**CITY OF TEMPE
DEVELOPMENT REVIEW COMMISSION**

**Meeting Date: 10/28/2014
Agenda Item: 3**

ACTION: Request for a Use Permit and Development Plan Review approval for a second residential unit added behind an existing house, with tandem parking for RESIDENCE AT FARMER, located at 1114 South Farmer Avenue. The applicant is Paul Fleager.

9.20.14
1114 S Farmer Avenue, Tempe, AZ 85281
Building Elevation Exhibit
Materials & Colors

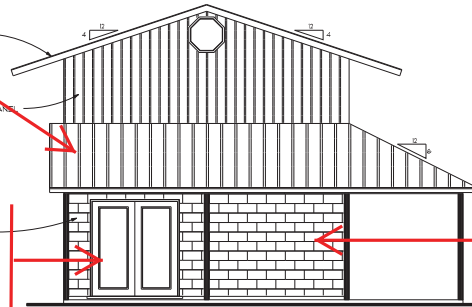
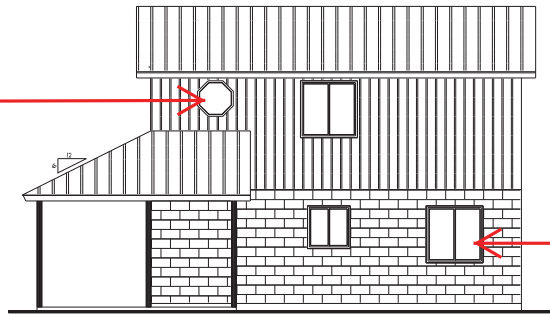
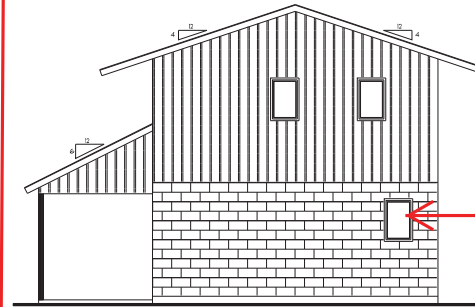
The design of the rear unit does not match the original roof pattern of the kit-built homes, but matches the orientation and pitch of a later addition to the rear of the original residence, and allows a more efficient use of the second floor space. When viewed from the street the second unit has a height that is consistent with the existing ridgeline of the main house.

The materials and colors proposed for the secondary unit are dissimilar to the existing residence. The applicant intends to make modifications to the existing residence to incorporate the standing seam roof, and fiber cement siding materials in matching colors on the original house after the secondary house is completed. The proposed colors and materials are appropriate to the context of the area, but would be incongruous if not applied to the existing house on site. The recommendation for approval of the colors and materials for the rear structure is contingent upon being applied to the front structure in a timely manner, not left to an unspecified future date. The following conditions of approval are not included, but listed as a consideration. These require that the existing house be re-sided and re-roofed with the same materials as the second residence, prior to certificate of occupancy of the second residence.

Replace the roofing on the original house with matching standing seam metal roofing, to match the second residence prior to certificate of occupancy for the second residence.

Replace the asbestos siding on the original house with matching fiber cement siding, to match the second residence prior to certificate of occupancy for the second residence.

8. The materials and colors are approved as presented:
Roof – standing seam steel roofing manufactured by Fabral, product: Horizon 16 – color: charcoal gray 851.
Lower walls – split faced CMU – grey color, not painted
Upper walls – fiber cement vertical siding – color: either 1010-5 "Spanish Tile" or 1011-5 "Royal Garnet"
Roof fascia – Material and color to match upper walls.
Window frames – vinyl windows manufactured by BetterBilt 100 series vinyl windows, color: Bronze.
